**Brookhaven National Laboratory
Plant Engineering - E&CS Division
Engineering Change Notice Form**

PROJECT: CCWF II

ECN Title: Sanitary Piping

ECN No. 18

Part Plan MP-106

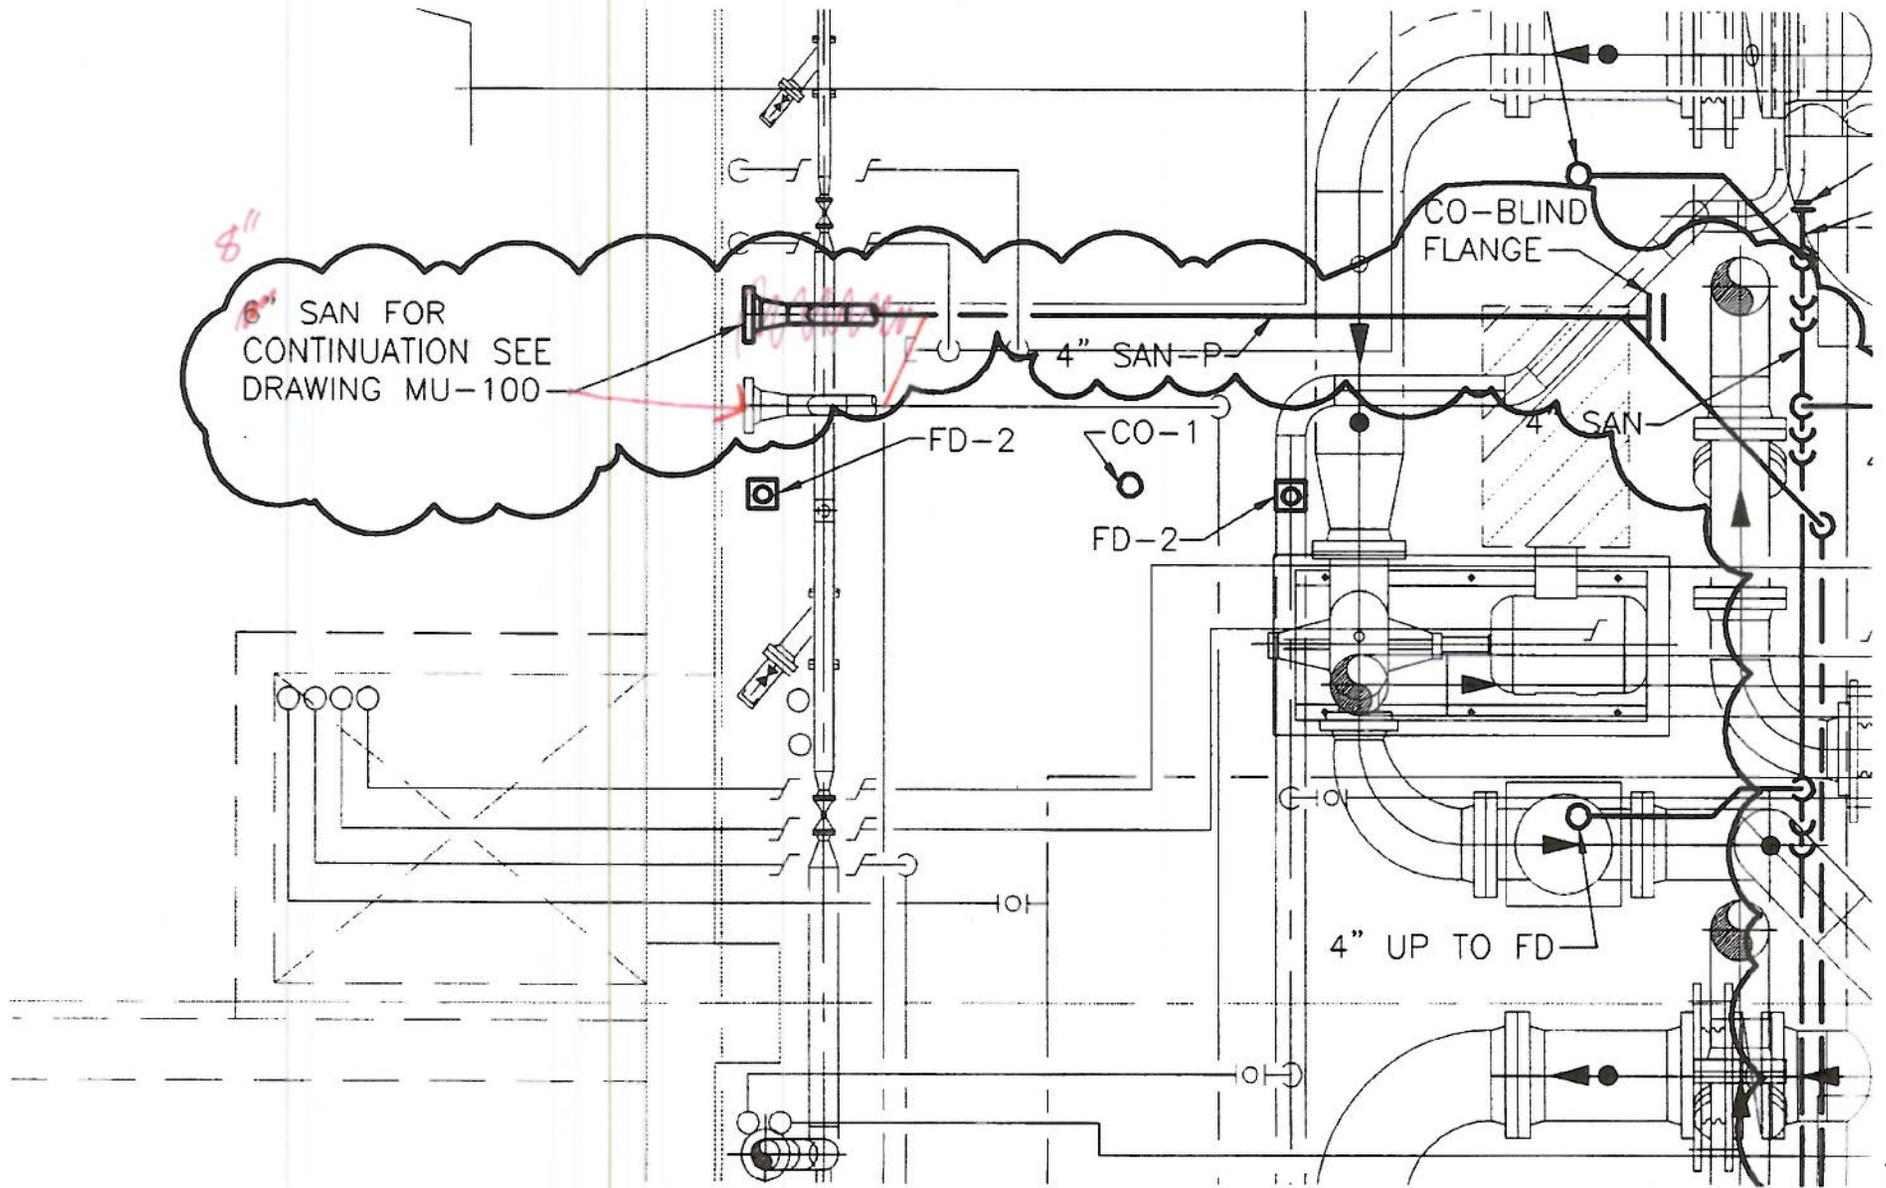
Requested Change (Attach sketch if applicable): To reduce joints buried under the toilet/locker/shower area, combine the (2) 6" sanitary lines into (1) 8" sanitary line. After exiting the West wall of the Women's Locker Room, "Y" the 8" and 4" sanitary together after the house trap. There are (3) pipe sleeves in the wall now; use the two southern pipe sleeves.
There will only be (1) manhole located over the existing 12" sanitary line instead of (2) new manholes.

Resolution: Approved. See attached Sketches and Plumber's isometric.
